Docket Number:	19-AB-2127
Project Title:	Implementation of AB 2127 Electric Vehicle Charging Infrastructure Assessments
TN #:	252335
Document Title:	Vehicle Grid Integration Council (VGIC) Comments - on Draft Second AB 2127 Assessment Workshop
Description:	N/A
Filer:	System
Organization:	Vehicle Grid Integration Council (VGIC)
Submitter Role:	Public
Submission Date:	9/20/2023 4:54:00 PM
Docketed Date:	9/20/2023

**Comments of VGIC on Draft Second AB 2127 Assessment
Workshop**

Implementation of AB 2127 Electric Vehicle Infrastructure Assessments

Figure 2: Projected Statewide Power for Light-Duty Vehicle Charging for 7.1 Million Zero-Emission Vehicles on a Typical 2030 Weekday

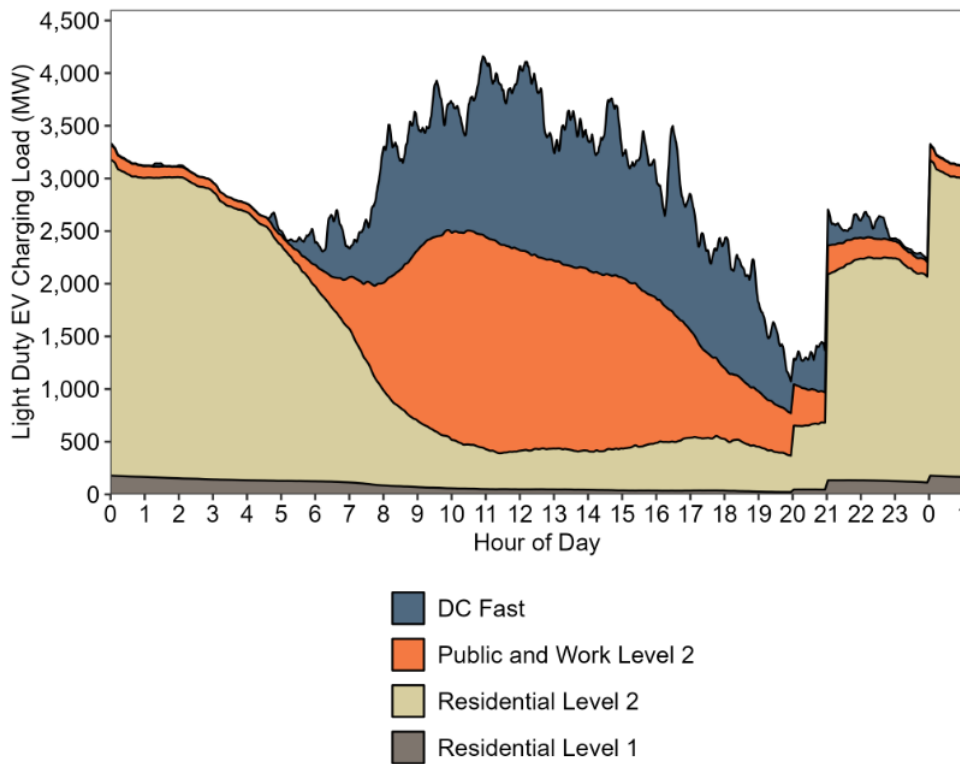
In pursuit of this increased coordination, the CEC should prioritize infrastructure investments in public and workplace Level 2 charging and other daytime charging sites, as demonstrated in the Draft AB 2127 Report’s Figure 2 below.² Combined with bidirectional charging, daytime solar energy production can be sent back to buildings and the grid in the early evening during the challenging net peak hours that utilities face. Furthermore, bidirectional vehicles with V2X technology can help manage the ramping of conventional generation resources when the solar resource declines in the late afternoon hours. In essence, V2G is the ideal asset class to address California’s worsening “duck” curve challenge.³
